Subject: LaSalle County Station Unit 1  
Requested Additional Information  
Regarding SRV Blowdown Test  
NRC Docket Nos. 50-373

This letter provides the additional information regarding the LaSalle Unit 1 SRV Blowdown Test requested in Reference (a). The attachments to this letter include data plots of untouched automated recordings made by Wyle Laboratories during the tests. Also included is a discussion and justification of the methodology used in determining the average local-to-bulk pool temperature difference to be 8.1°F.

RESPONSE TO REQUEST FOR ADDITIONAL INFORMATION  
REGARDING SRV BLOWDOWN TEST

SKETCH OF SENSOR ORIENTATION  
IN LASALLE UNIT 1 SUPPRESSION POOL  
(0.5 cm = 1'-0")

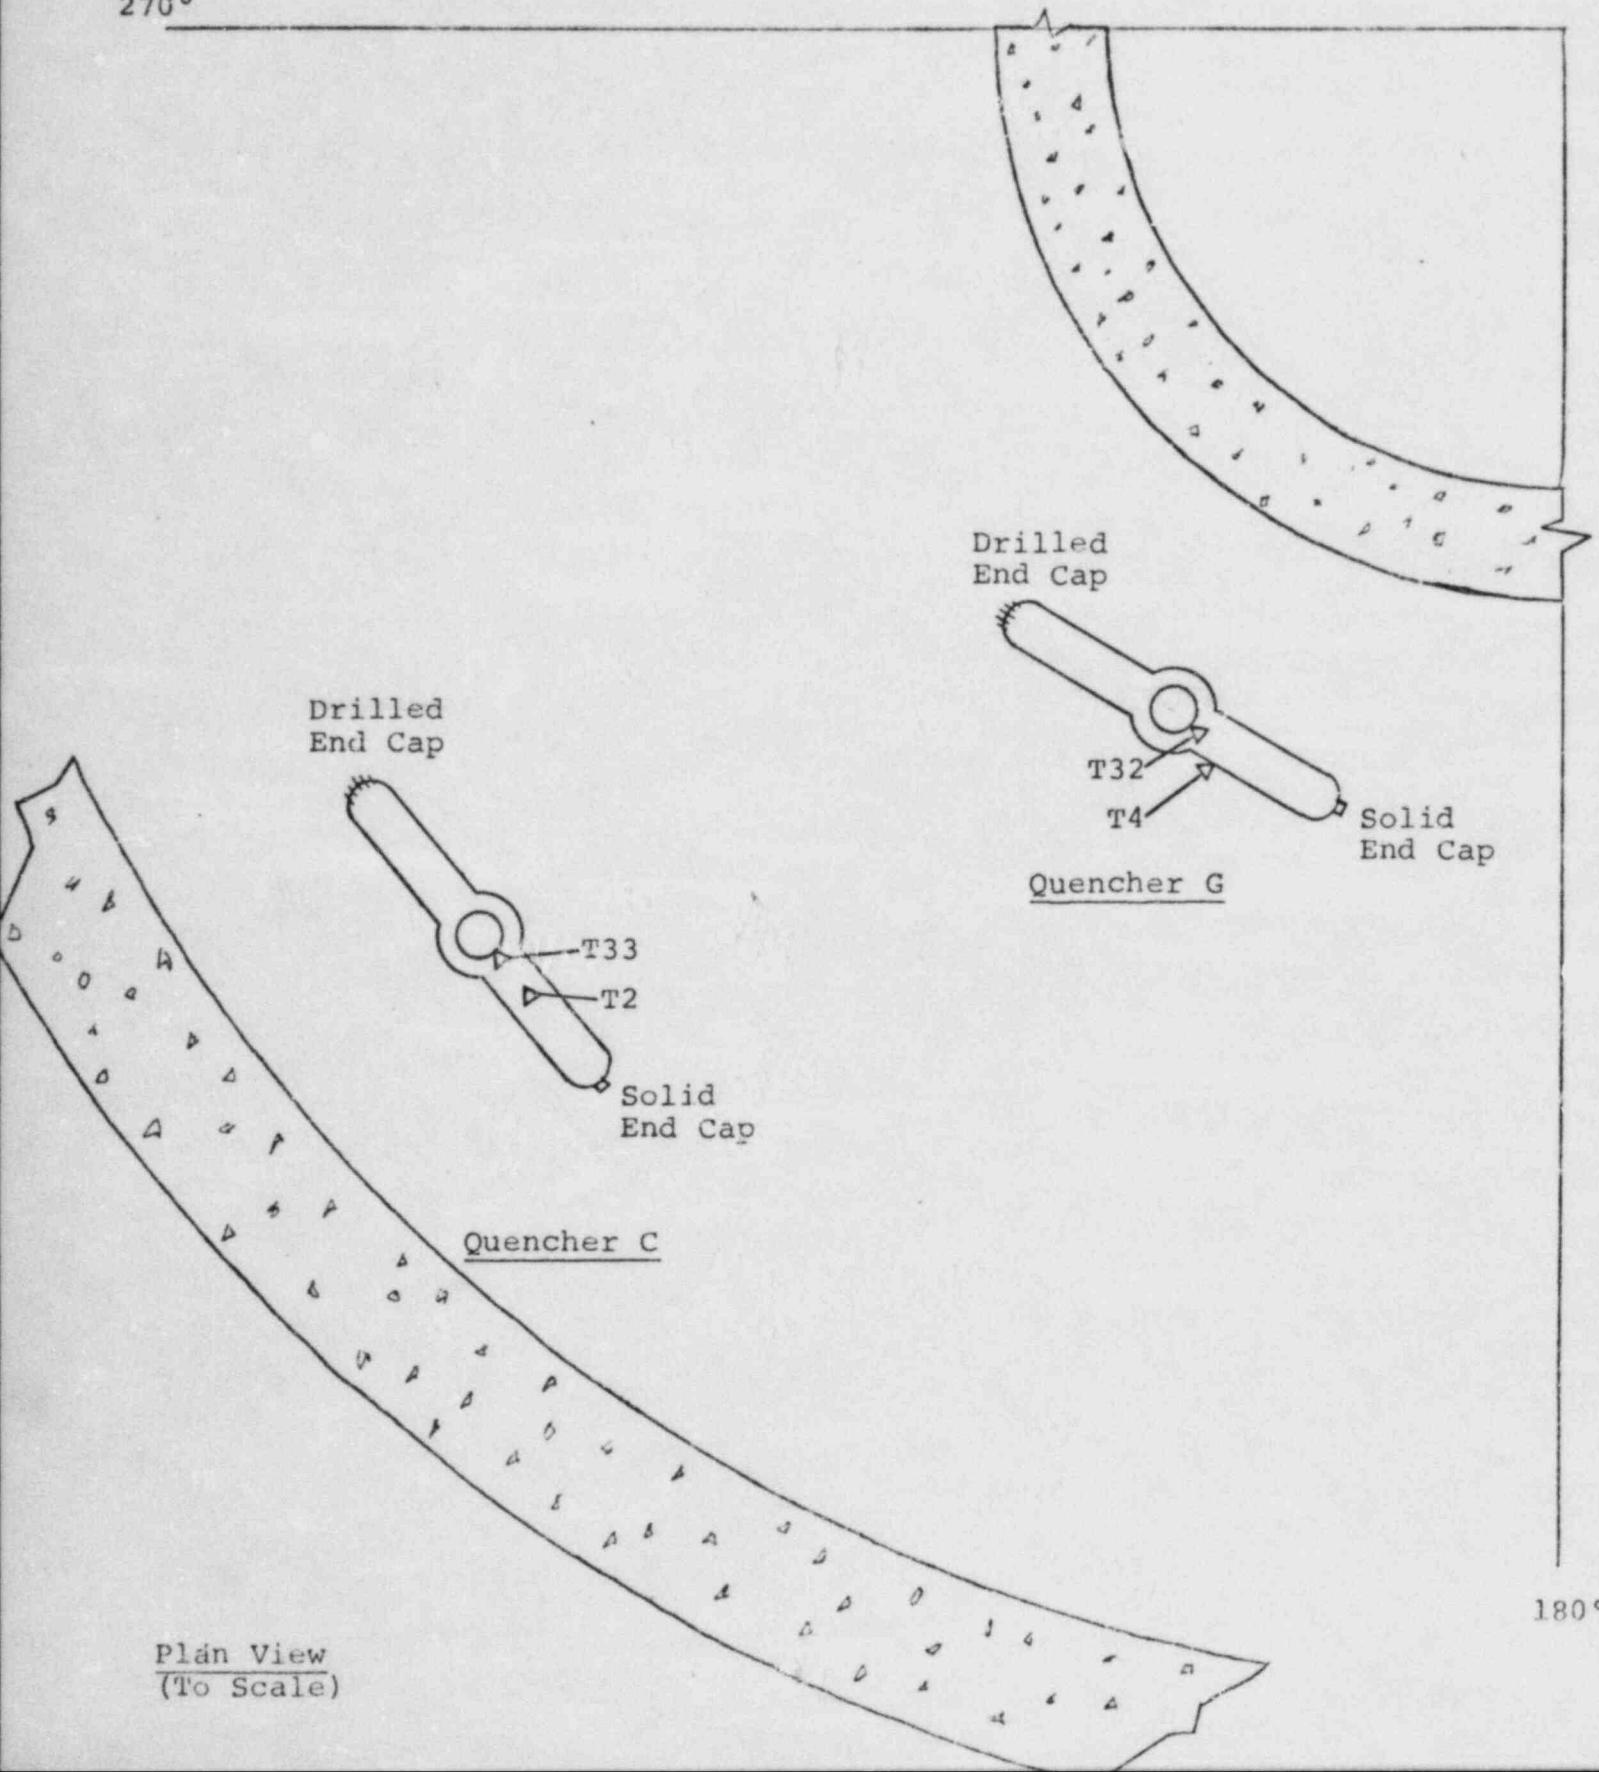
This response provides the information requested in the A. Schwencer letter of August 17, 1984 [1]. Attachment 1 is a sketch of the test temperature sensor locations relative to the quencher end cap holes. Attachment 2 is a set of recorded temperature responses for all the sensors. These plots were prepared by Wyle Laboratories.

We agree with this characterization of the general flow pattern surrounding a discharging quencher. Consequently the sensors chosen to represent the local pool temperature were those mounted directly above and below the quencher. Other sensors were not used because:

While it may be permissible to use these sensors, NUREG-0783, as previously mentioned, supercedes these guidelines and clearly states a preference for more locally mounted sensors. These were the sensors used in the computations of local-to-bulk pool temperature (e.g., T2, T4, T32, T33).

3) The four sensors used to compute local pool temperature (two per quencher) were mounted upstream of the quencher centerline relative to the bulk pool motion induced by steam discharge from the end caps as well as by RHR flow. These sensors were mounted in this location to better measure the temperature of the inflowing water. It has been correctly pointed out that sensors mounted downstream of the quencher center would have provided a more conservative measure of the local-to-bulk pool temperature difference. However the following points should be noted
